U.S. Department of the Interior **BUREAU OF LAND MANAGEMENT**  Sundry Print Report

Well Name: BLANCO WASH Well Location: T24N / R9W / SEC 1 /

#### **Notice of Intent**

# **Notice of Intent - Plug and Abandonment**

#### **Planned P & A Schematic**

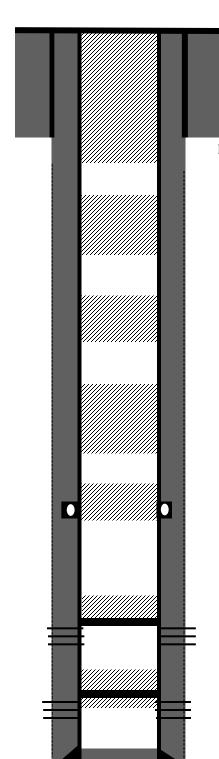
- a. Adjust Plug 4 (Mesaverde-Lower Chacra) to cover BLM geologist's Mesaverde and Lower Chacra formation top picks @ 3405' and 2693', respectively. Plug 3 should cover at a minimum 2643' 3455', estimated minimum 64 sx.

- b. Adjust Plug 5 (Upper Chacra-Picture Cliffs) to cover BLM geologist's Upper Chacra and Picture Cliffs formation top picks @ 2351' and 1830', respectively. Plug 5 should cover at a minimum 1780' 2401', estimated minimum 49 sx.

- c. Adjust Plug 6 (Fruitland-Kirtland-Ojo Alamo) to cover BLM geologist's Fruitland, Kirtland, and Ojo Alamo formation top picks @ 1569', 1280', and 845', respectively. Plug 6 should cover at a minimum 795' 1619', estimated minimum 65 sx.

**Remarks:** Adjust plugs to cover BLM-picked formation tops- plug IV to cover BLM-picked Cliffhouse Fm, plug V to cover BLM-picked Pictured Cliffs, and Plug VI to cover BLM-picked Ojo Alamo Fm.
